Request from Evangel Retirement Homes, Inc. (owner) represented by Robert Dahl (officer) to rezone property located at 2600 Hubbell Avenue and approve a PUD Conceptual Plan for "Valley View Village".			File # ZON2007-00142	
Description of Action	Rezone property from "R-3" Multiple-Family Residential District and "FW" Floodway District to "PUD" Planned Unit Development and approve a PUD Conceptual Plan to allow redevelopment of the existing retirement community in a phased master plan approach including the addition of new independent apartments, assisted living apartments, catered living, and brownstone townhomes to replace existing independent cottages, custodial living, and skilled units, bringing the total from 261 existing units to 336 units at completion of the plan.			
2020 Community Character Plan	High-Density Residential.			
Horizon 2025 Transportation Plan	Guthrie Avenue from I-235 to Hubbell Avenue to widen from 2 lane undivided to 3 lane undivided.

Valley View Village - 2571 Guthrie Avenue

ZON2007-00142

(1) **SITE/LANDSCAPE PLAN**
 A2 1"=60'-0"

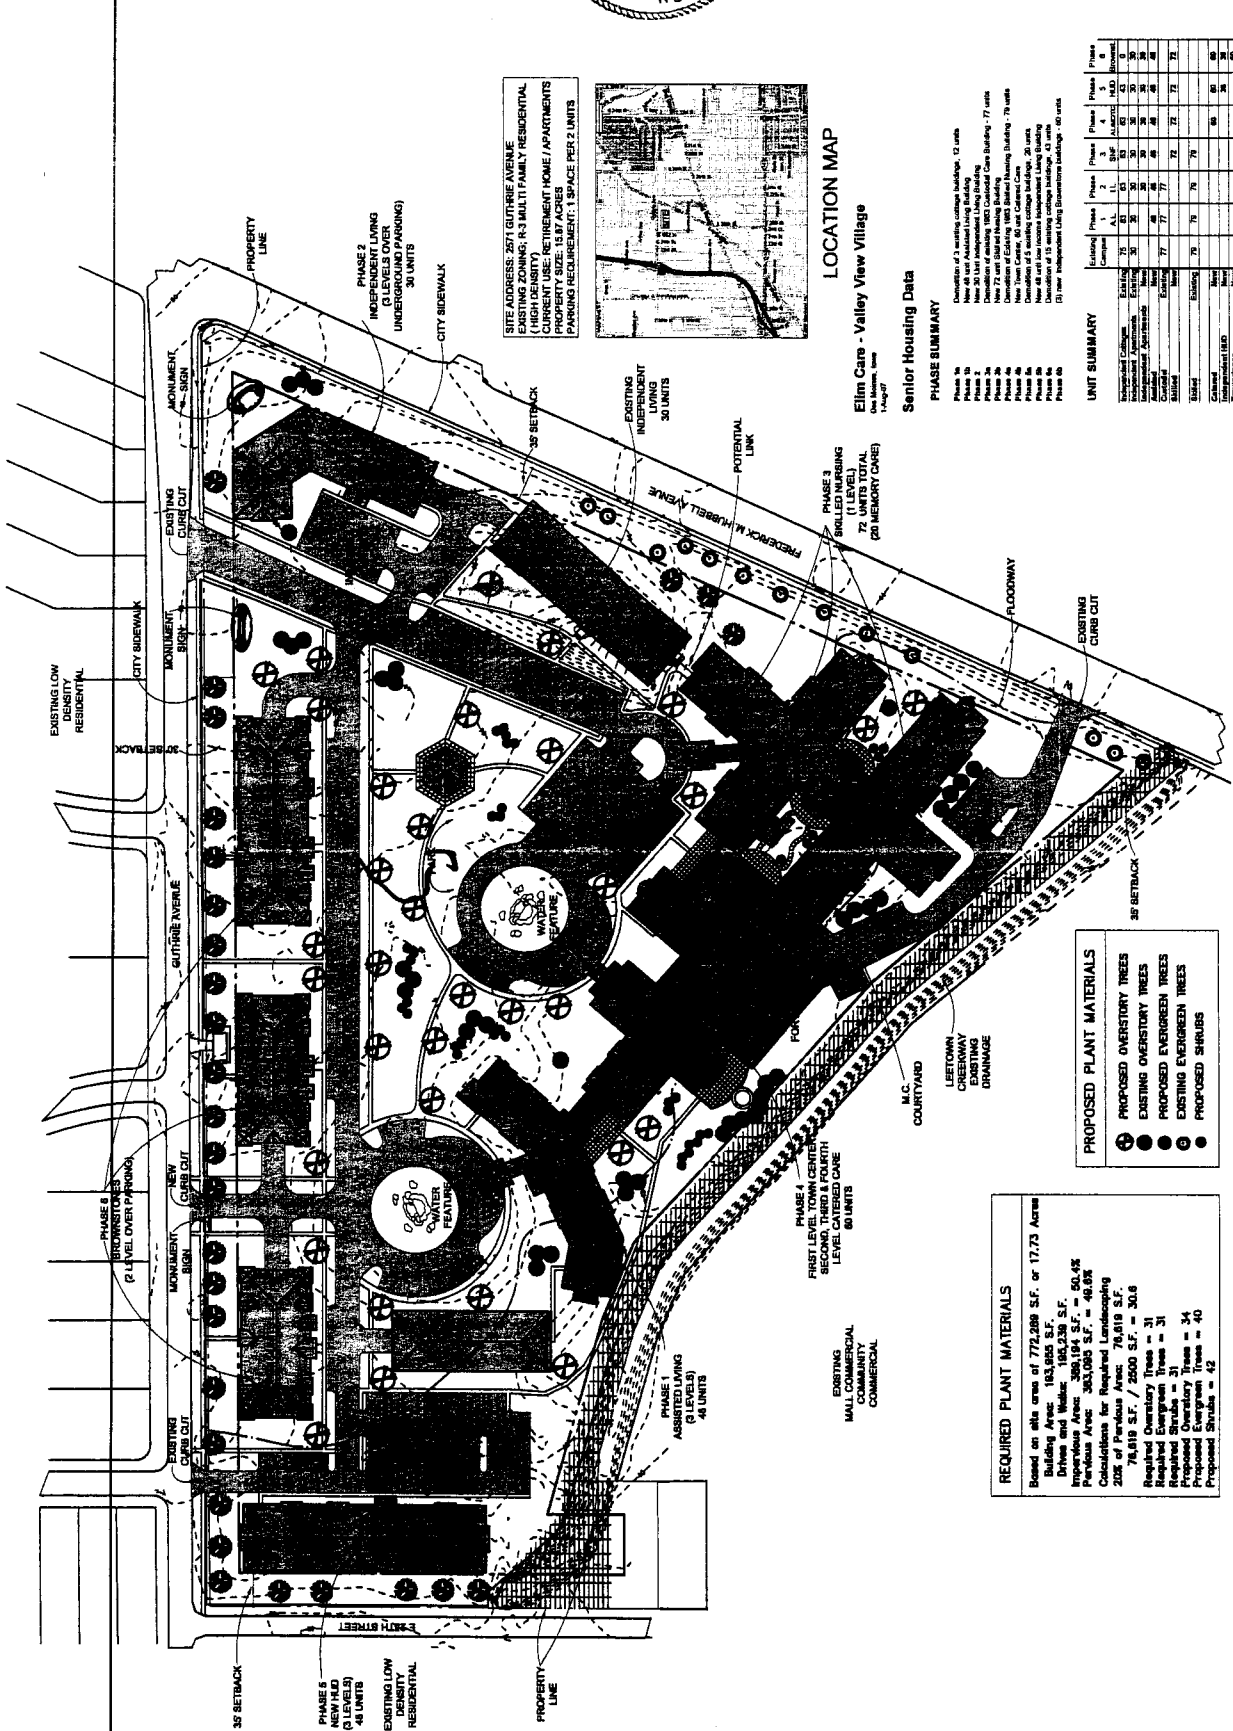
1. The PUD Conceptual Plan is amended to either exclude the portion that is zoned "FW" Floodway or to reflect the boundary of the engineered floodway to define the areas impacted by flooding.

2. Provision of a statement that a survey of all trees over 6" in caliper for the areas in which trees will be removed shall be submitted at the PUD Development Plan review phase.

3. Provision of a statement that no tree removal, grading, or construction shall occur on the site until the PUD Development Plan is approved.
4. Provision of a turnaround at the west terminus of the 390' dead-end service drive along the south edge of the project site.

5. Provision of a statement that any canopy over an access drive shall be constructed with a minimum vertical clearance of 13'-6".
6. Provision of a statement that all landscaping will be in accordance with minimum landscape standards as applied to the "R-3" Multiple-Family Residential District.

7. Provision of a sidewalk along East 25th Street.
8. Provision of sidewalk connections from all buildings to the sidewalks along public streets.
9. Provision of a statement that at least 15% of the facade would be stone and/or masonry materials, with the remainder being hard surface material such as stucco or hardi-plank siding.

10. Provision of a statement that all roofing material shall be architectural-type shingles of a color to complement the stone or masonry materials.

11. Provision of a statement that any fencing on the site be in accordance with the regulations as applicable to the "R-3" District and that any chain link fence shall be clad with black vinyl.
12. Provision of a statement that any dumpster enclosure shall be constructed with masonry materials to match the proposed structures.

- 3. Fire Protection:** A turnaround must be provided at the westerly terminus of the 390' dead-end service drive along the south edge of the project site, as this drive is required for fire apparatus access. In accordance with 2006 IFC Section 503.2.5, dead-end fire apparatus roads in excess of 150' in length shall be provided with an approved area for turning around fire apparatus. A note must also be provided on the Concept Plan to indicate that any canopy over an access drive shall be constructed with a minimum vertical clearance of 13'-6".

The Conceptual Plan demonstrates numerous pedestrian connections on the site. Staff recommends that in addition to the proposed sidewalks, the Conceptual Plan should include a sidewalk along East 25th Street, as well as sidewalk connections from all buildings to the sidewalks along public streets.

The proposed Concept Plan does not indicate fencing would be permitted on the site. Staff recommends that a note be added to state that any fencing on the site be in accordance with the regulations as applicable to the "R-3" District and that any chain link fence shall be clad with black vinyl.

Staff recommends that a note be added to the Concept Plan stating that any dumpster enclosure shall be constructed with masonry materials to match the proposed structures.

EXTERIOR
ELEVATIONS
& SIGNS

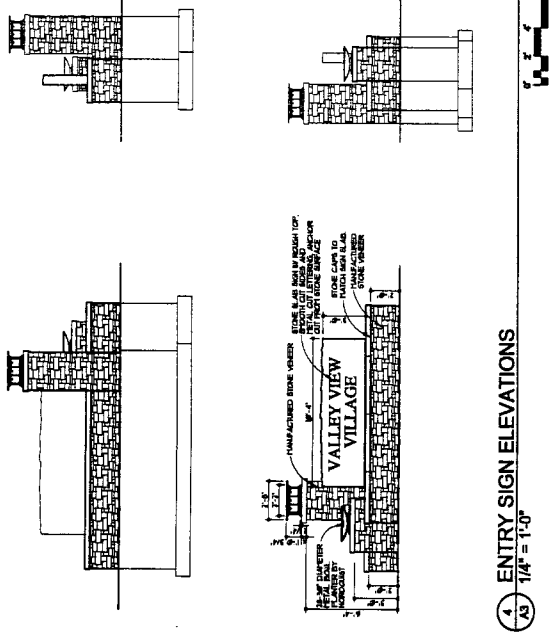
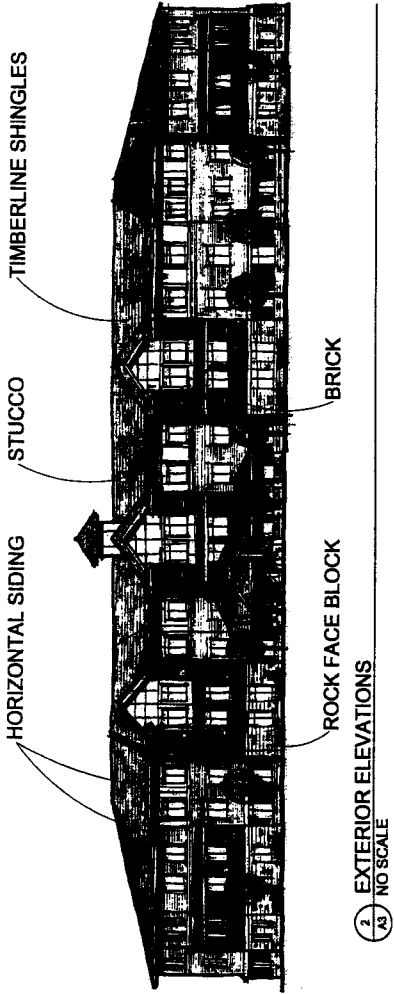
7. **2020 Community Character Plan:** The proposed 338 dwelling units on 17.73 acres represents a density of 18.95 units per acre, which is in conformance with the High-Density Residential land use designation.
8. **Urban Design:** The submitted elevations indicate that all structures would have a common architectural theme. According to the submitted renderings and narrative, at least 15% of all facades would be stone and/or rock-faced block. The remainder will be hard surface material such as brick, stucco, and cement board siding. Roofing would be a profile (architectural) shingle of a color to complement the stone. Staff recommends that the notes provided in the narrative regarding construction materials be transferred to the Concept Plan.

The elevations indicate that significant articulation of the structures would be achieved through variation of rooflines, setbacks, patterns of door and window placement, and the use of characteristic entry features. The elevations also indicate that structures would have multiple gables to break up expansive roof plains.
